Access Compliance Report

Public Rights-of-Way

(Pedestrian Signals)

Intersection ID: N/A	Main Street:	Cross Street: N/A	Location: N/A
ADA ID: 072EE15C2643	Signal Type: One Push Button-Non APS	Overall Compliance: No	Severity Score: BTN 1: N/A BTN 2: N/A No BTN: N/A
Codes/Mitigation Info/Possible Solution		Field Measurements/Component Compliance

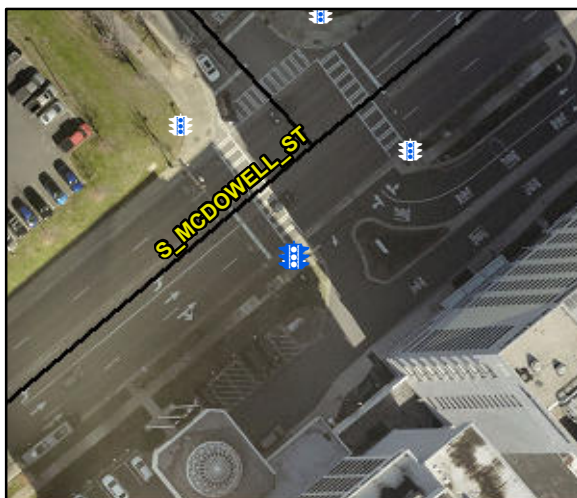
Possible Solutions: Replace Signal Push Button With APS Button. Provide PAR As Indicated. Remove and Replace Clear Space.
